Access Compliance Report

Public Rights-of-Way

(Curb Ramps)

Intersection ID: 15071	Main Street: GREENBROOK_DR	Cross Street: TARRINGTON_AV	Location: NE
ADA ID: 26902241B824	Ramp Type: PerpDiag	Initial Pass/Fail: Pass	Overall Compliance: No
Codes/Mitigation Info/Possible Solution		Field Measurements/Component Compliance	
Severity Score: 10

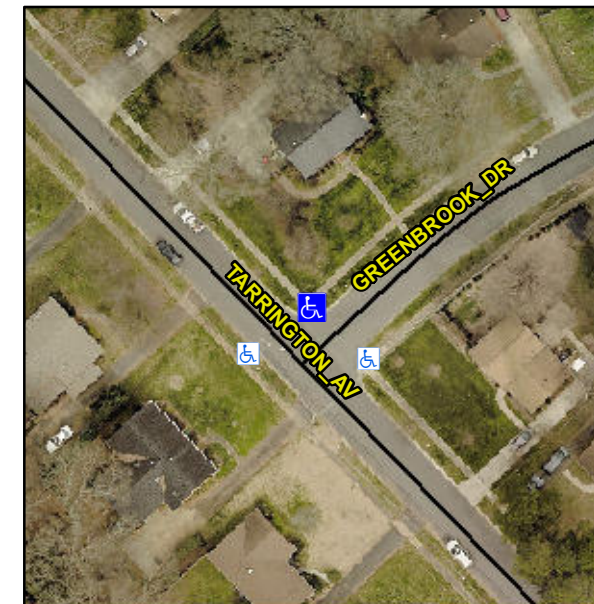
Not Found, R304.2.1, R304.2.2-Perp, R304.3.2-Para, R304.5.3, R305.2

Compliance	Description	Data	Compliance	Description	Data
N/A	Ramp Length (in)	54.0	Yes	Ramp Slope (%)	6.2
Yes	Ramp Width (in)	48.0	Yes	Ramp XSlope (%)	1.2
N/A	Flare Type LT	Sloped	N/A	Flare Type RT	N/A
N/A	Flare Slope LT (%)	2.9	Yes	Flare Slope RT (%)	8.7
N/A	Flare Traversable LT?	No	N/A	Flare Traversable RT?	Yes
No	Landing Length (in)	N/A	Yes	DWS Provided?	Yes
No	Landing Width (in)	N/A	Yes	DWS Contrast?	Yes
No	Landing Slope (%)	N/A	Yes	DWS Length (in)	24.0
No	Landing X Slope (%)	N/A	Yes	DWS Full Width?	Yes
N/A	Landing Curb? (Y/N)	No	No	DWS Offset (in)	4.5
N/A	Shared Landing?	N/A			
Yes	Gutter Ponding?	No	Yes	Gutter Slope (%)	0.6
Yes	Gutter Lip Ht (in)	0.0	Yes	Gutter X Slope (%)	0.9
N/A	Painted X Walk1?	No	N/A	Painted X Walk2?	No
	X Walk 1 Direction	To SW		X Walk 2 Direction	To SE
N/A	X Walk 1 Width (in)	N/A	N/A	X Walk 2 Width (in)	N/A
	X Walk 1 Slope (%)	5.1		X Walk 2 Slope (%)	4.5
	X Walk 1 X Slope (%)	3.7		X Walk 2 X Slope (%)	0.3

N/A	Ramp inside XWalk1?	N/A	N/A	Ramp inside XWalk2?	N/A
	Road Slope (%)	1.5	N/A	Clear Space?	Yes
	Road X Slope (%)	5.3	N/A	Clear Space to XWalk (in)	N/A
Yes	Any Obstructions?	No	Yes	Storm Grate/Utility Hazard?	No
	Obstruction Type			Storm Grate/Utility Type	
		N/A			N/A
			Yes	Surface Condition? (G/P)	Good

Remove & Replace Curb Ramp With Two New Directional Ramps or Equivalent.
